**LEBANON PLANNING BOARD
OCTOBER 24, 2022 - 6:30 PM
COUNCIL CHAMBERS, CITY HALL OR
REMOTE VIA VIRTUAL PLATFORM
LEBANONNH.GOV/LIVE**

**LWM Residential, LLC, 1 Foundry
Street (Tax Map 91, Lot 263), 25
Mechanic Street (Tax Map 91, Lot
267), and 43 Mechanic Street (Tax
Map 106, Lot 34), zoned LD
PB2022-36-SPR**

Staff Memorandum – PB2022-36-SPR – *con't from 10/10/22*

Subject: **Site Plan Review Application – Lebanon Woolen Mill Redevelopment
1 Foundry Street (Map 91 Lot 263); 25 Mechanic Street (Map 91 Lot 267);
and 43 Mechanic Street (Map 106 Lot 34); Lebanon, New Hampshire**
KNA Project No. 22-0819-1

Photometric Plan

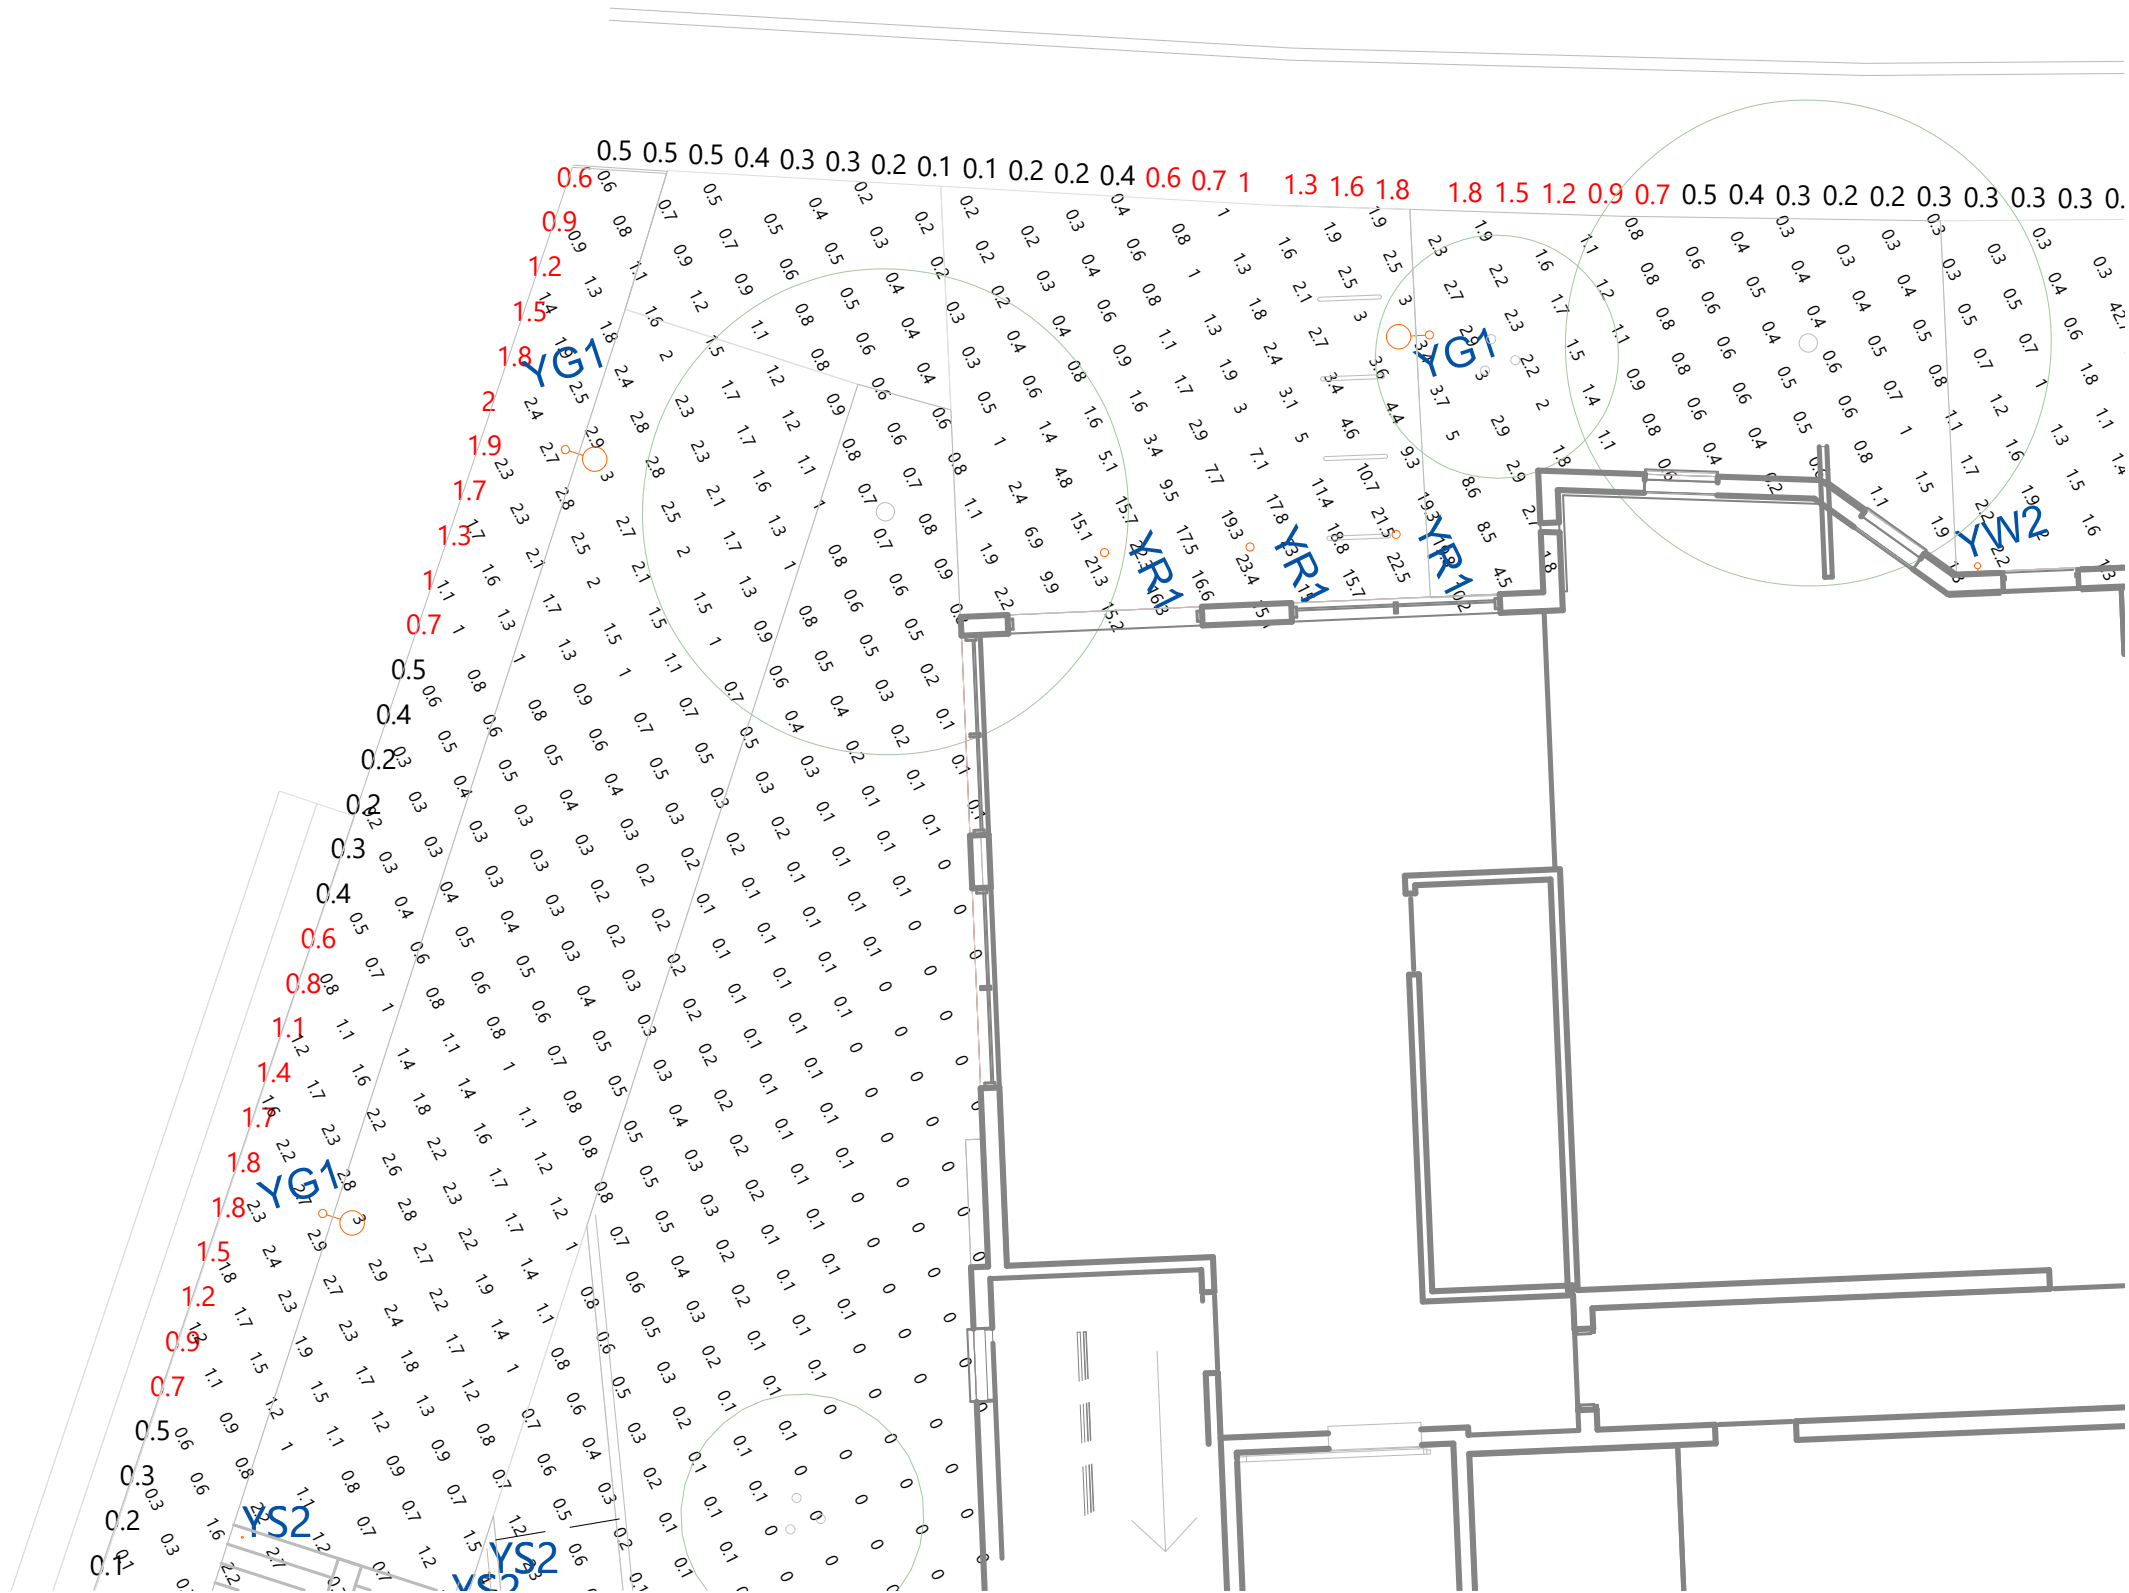
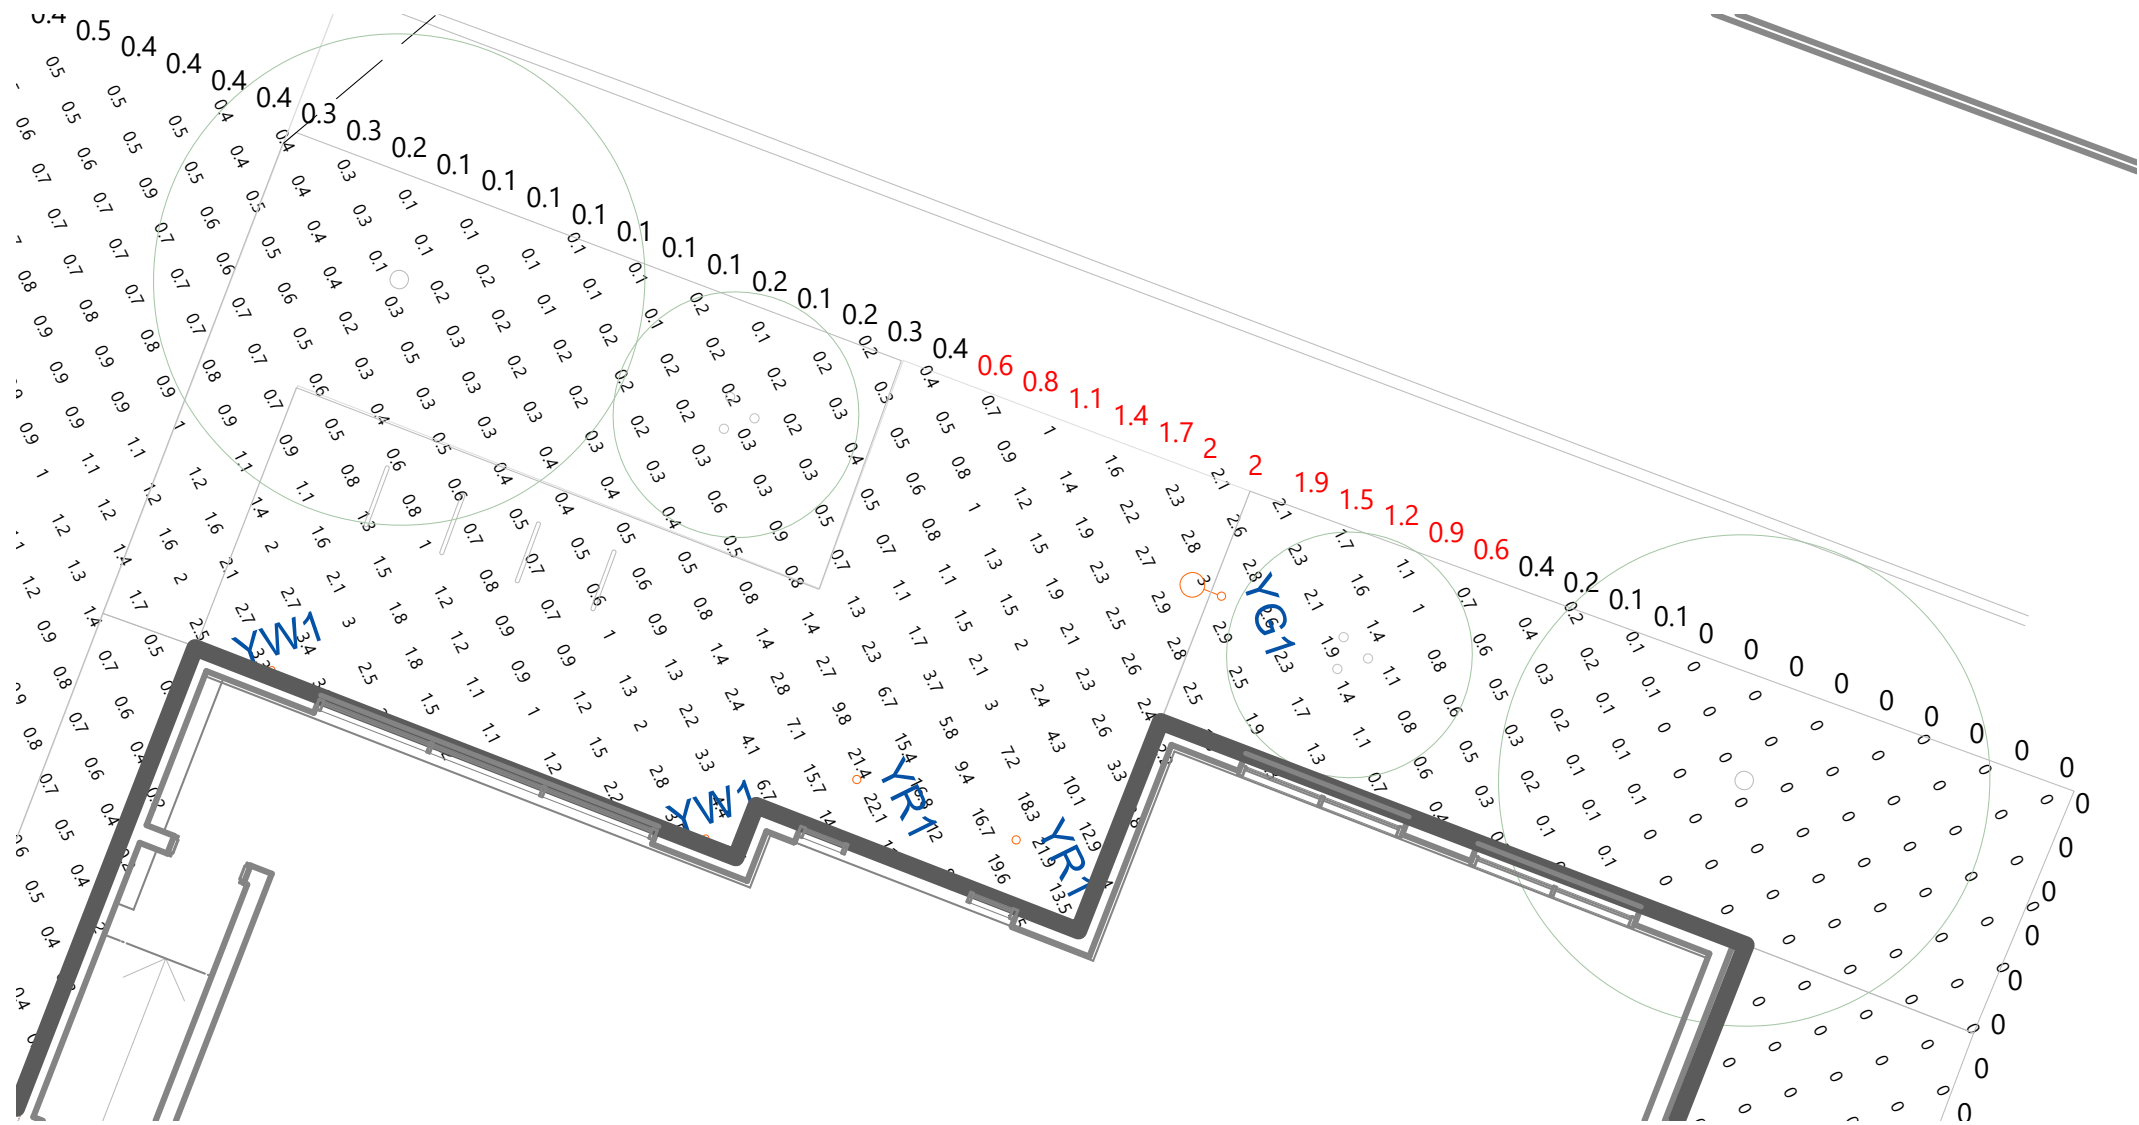
7) *Provide additional information regarding the lighting waiver requests?*

This resubmittal includes a revised site lighting photometrics plan which shows a reduced amount and intensity of the light trespass. The revised Application for Waivers also includes exhibits to better highlight the areas where waivers are still being sought. Light trespass of more than 0.5fc is still occurring near the lobby entries to 25 and 43 Mechanic Street and along the southern edge of the walkway down to the mill yard. These lighting levels are required to provide adequate pedestrian safety. Mechanic Street currently has overhead streetlights which illuminate the street and sidewalk with more than 0.5fc. As such, the trespass from the LWM project will not look out of place.

C-003

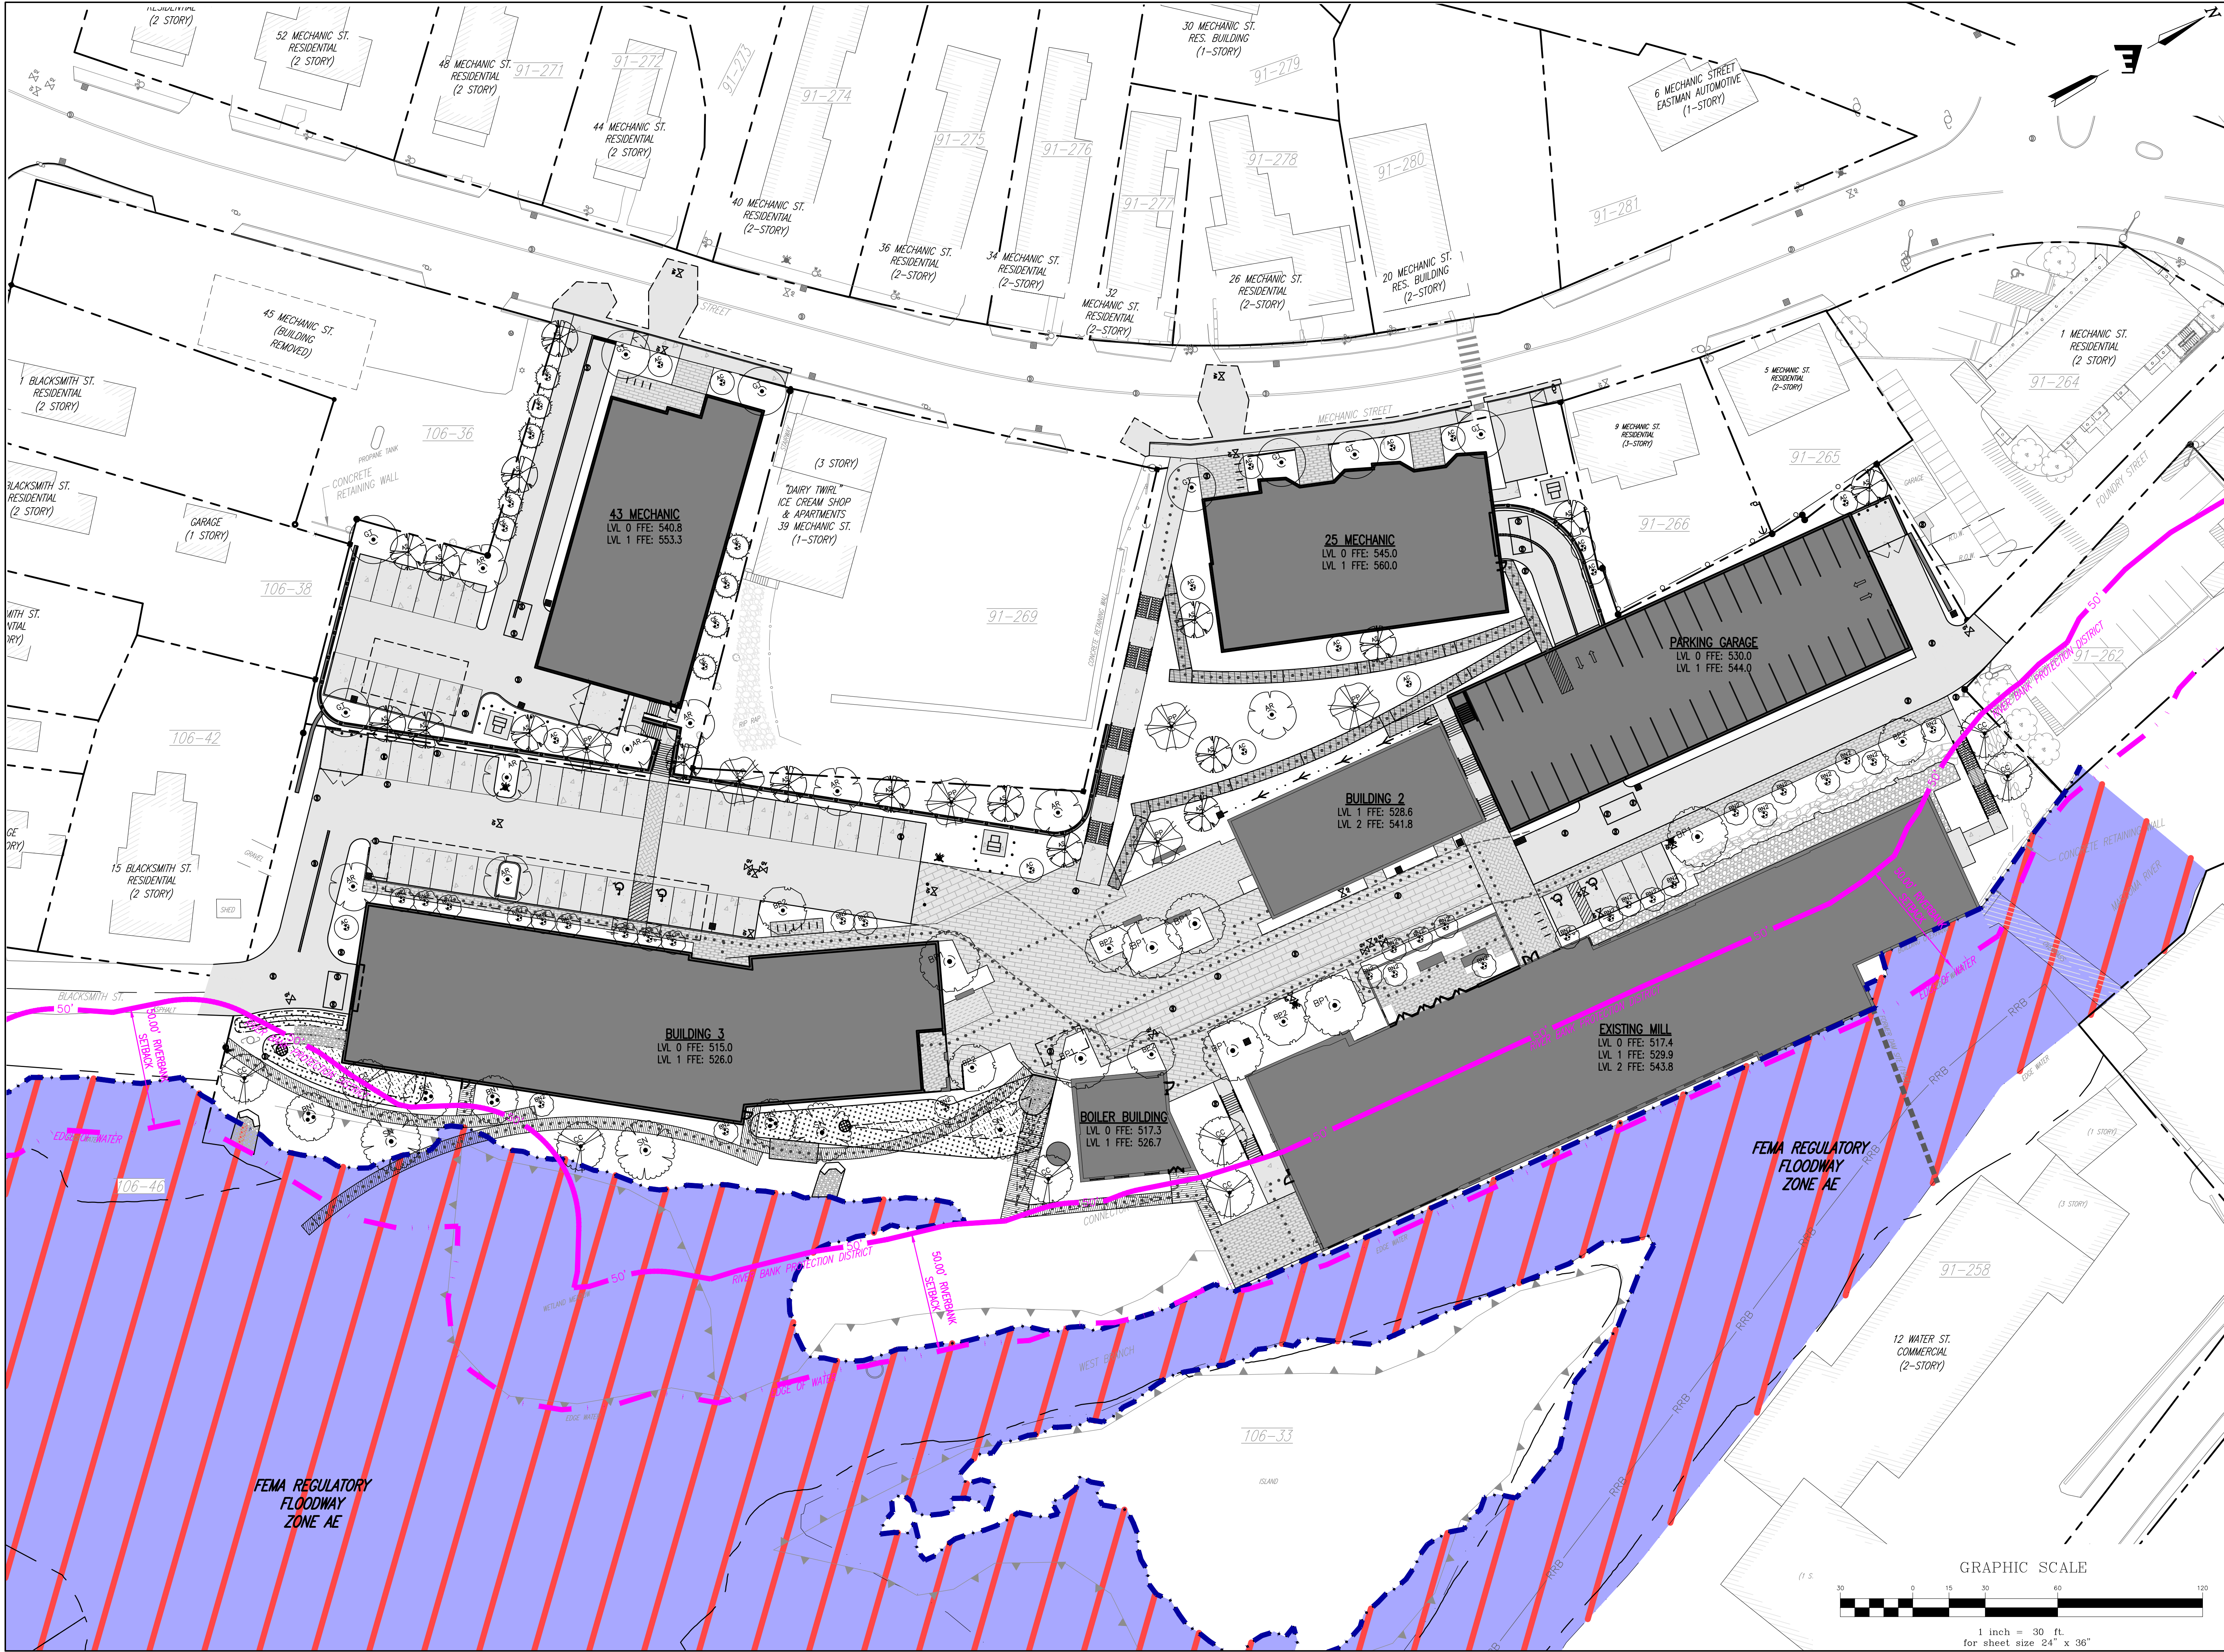
- 1) *Additional clarity on phasing plan – it needs to be clear exactly what improvements are included with each phase.*

This package includes a revised phasing plan which contains a better delineation of the limits of each phase.

EX1

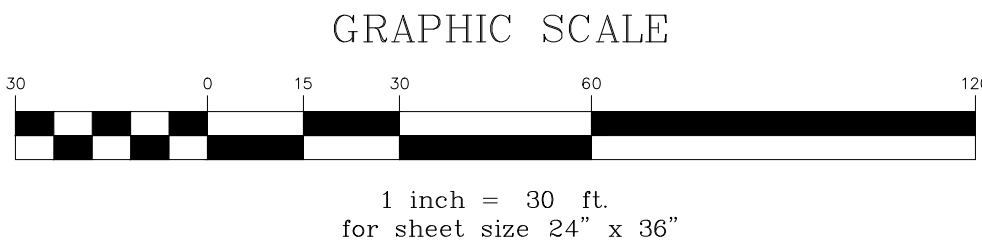
5) *Provide an exhibit better depicting the FEMA 100-year flood limits?*

Exhibit EX1 Flood Hazard Exhibit was provided to the Lebanon Planning Department by e-mail on October 17, 2022.
